SAFETY EVALUATION BY THE OFFICE OF NUCLEAR REACTOR REGULATION
RELATED TO THE INSERVICE TESTING PROGRAM'S THIRD TEN-YEAR INTERVAL

OMAHA PUBLIC POWER DISTRICT

FORT CALHOUN, UNIT 1

DOCKET NO. 50-285

Figure 1

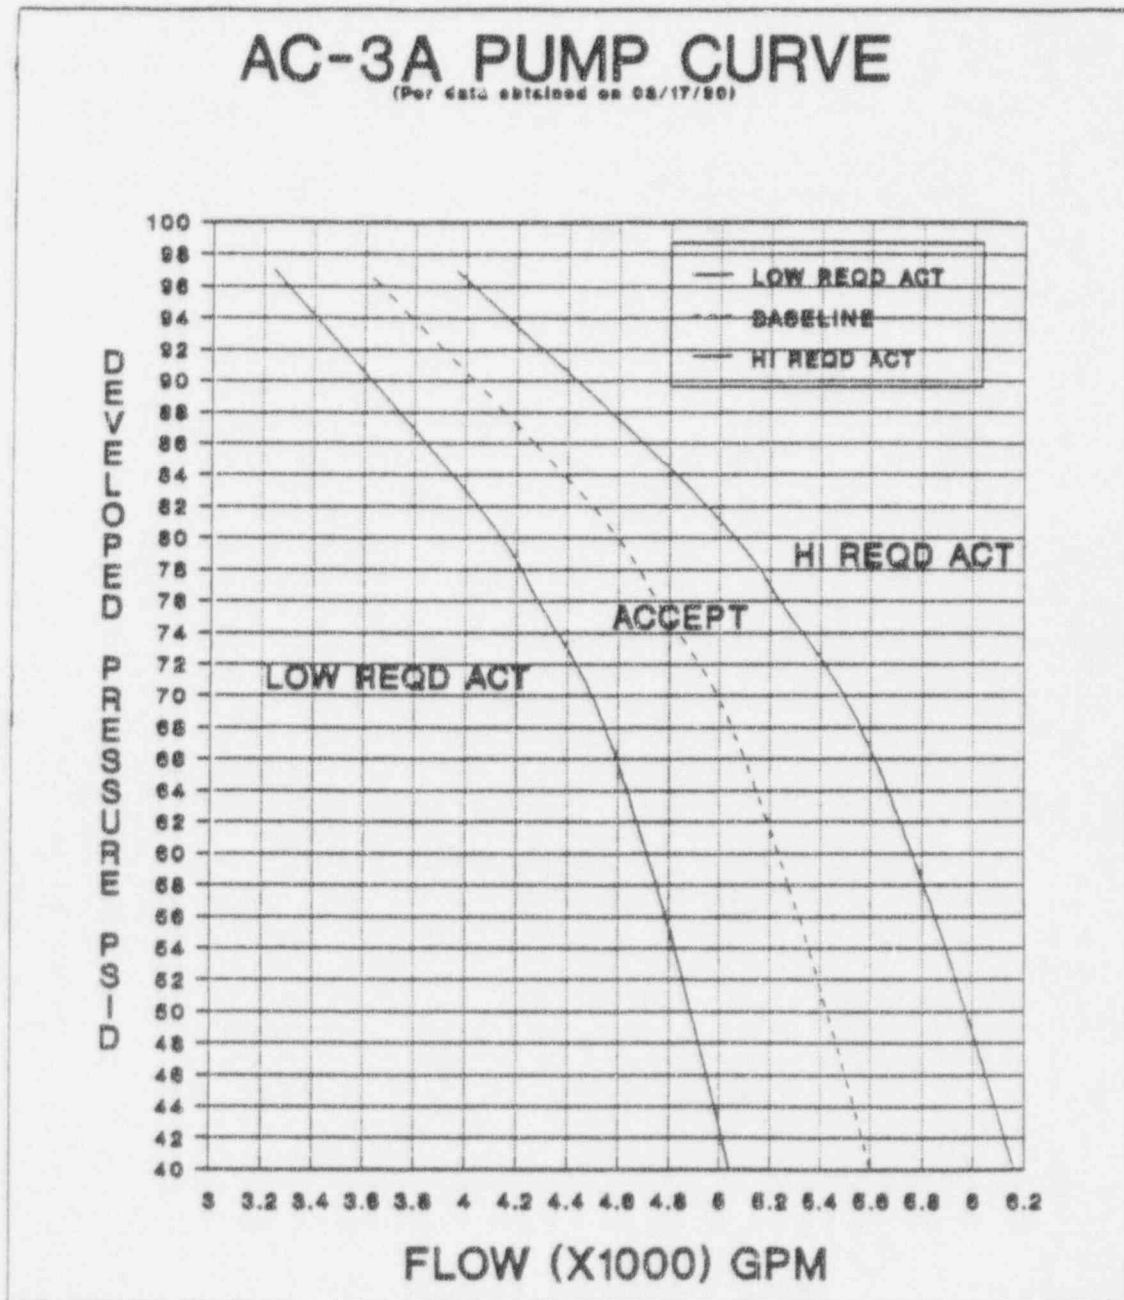
6. The reference pump curves are based on differential pressure vs. flow. See the attached sample AC-3A and AC-10A pump acceptance criteria sheets [see Figures 1 and 2]. Areas for Required Action are as shown for AC-3A in [Figure 1]. Areas for Acceptable, Alert, and Required Action are as shown for AC-10A in [Figure 2]. These acceptance criteria limits do not conflict with operability criteria (minimum operability) as shown on [Figures 1 and 2].

Relief to use pump curves for testing the RW and CCW pumps is granted pursuant to 10 CFR 50.55a(f)(6)(i) based on the impracticality of performing testing in accordance with the Code requirements to test pumps at a reference value of either differential pressure and measure flow, or flow and measure differential pressure. The granting of relief is in consideration of the adequacy of an alternative method of testing and the burden if the Code requirements were imposed.
